# UNITED STATES PATENT AND TRADEMARK OFFICE

<b>Office Action Summary</b>	<b>Application No.</b> 10/583,966	<b>Applicant(s)</b> YAGISAWA ET AL.
	<b>Examiner</b> Aaron M. Dunwoody	<b>Art Unit</b> 3679

**DETAILED ACTION**

Fig. 3

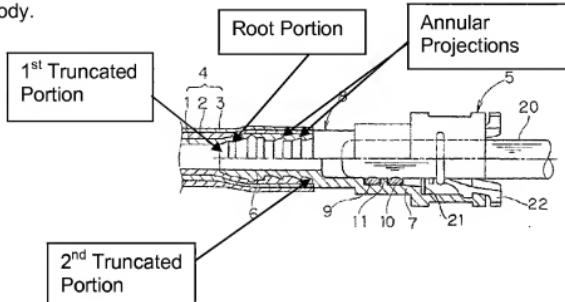
In regards to claims 1, 2, 4, 5, 7-10, 12 and 13, in Figure 3 below, Nishiyama et al disclose a resin tube-equipped quick connector for connecting a fuel-transporting resin tube (4) to a mating pipe, comprising a connector body (5), a retainer (22) and a seal member (9, 10); wherein the connector body has a generally tubular shape as a whole, and has a retainer holding portion at one axial side thereof, and also has at the other side thereof a press-fitting portion which is press-fitted into the interior of the resin tube from one end thereof, the press-fitting portion extends by a predetermined length L between a ring-shaped end face of the connector body and an ring-shaped end face of the press-fitting portion wherein the retainer is a member adapted to be held in the retainer holding portion, and is engaged with a convex or concave pipe-side engagement portion, formed on an outer peripheral surface of the mating pipe and

spaced from an axial insertion-side end thereof, so as to fix the inserted mating pipe in the axial direction; wherein the seal member is mounted within the connector body at an inner region thereof disposed closer to the press-fitting portion than the retainer holding portion is disposed, and the seal member is brought into contact with an outer peripheral surface of an insertion end portion of the inserted mating pipe disposed closer to the distal end of the mating pipe than the pipe-side engagement portion is disposed, thereby forming an air-tight seal between the insertion end portion and an inner surface of the connector body; and the resin tube including a press-fit undergoing portion into which the press-fitting portion is press-fitted, wherein before the press-fitting portion is press-fitted into the press-fit undergoing portion, when the press-fit undergoing portion is formed with an inner diameter that is substantially equal to an outer diameter of the root portions of the press-fitting portion, and after the press-fitting portion is press-fitted into the press-fit undergoing portion of the resin tube, the press-fit undergoing portion is adapted to cause portions of its inner diameter facing the root portions to become equal to the outer diameter of the root portions, so that and the press-fit undergoing portion is integrated with the press-fitting portion in a withdrawal-preventing condition, wherein the press-fitting portion is provided along the length L with the following portions, one immediately after another: a first truncated-conical-shaped portion extending from the ring-shaped end face; a cylindrical-shaped root portion, the plurality of truncated-conical-shaped annular projections each followed by a ring-shaped face and another cylindrical-shaped root portion, a second truncated-conical-

shaped portion, which ends abutting with the ring-shaped end face of the connector body.

Nishiyama also includes an insert portion (6). It would have obvious to one having ordinary skill in the art at the time the invention was made to omit the insert portion (6), since the omission of an element and its function in a combination, where the remaining elements perform the same functions as before, involves only routine skill in the art. In re Kuhle, 526 F.2d 553, 188 USPQ 7 (CCPA 1975); In re Karlson, 311 F.2d 581, 136 USPQ 184 (CCPA 1963).
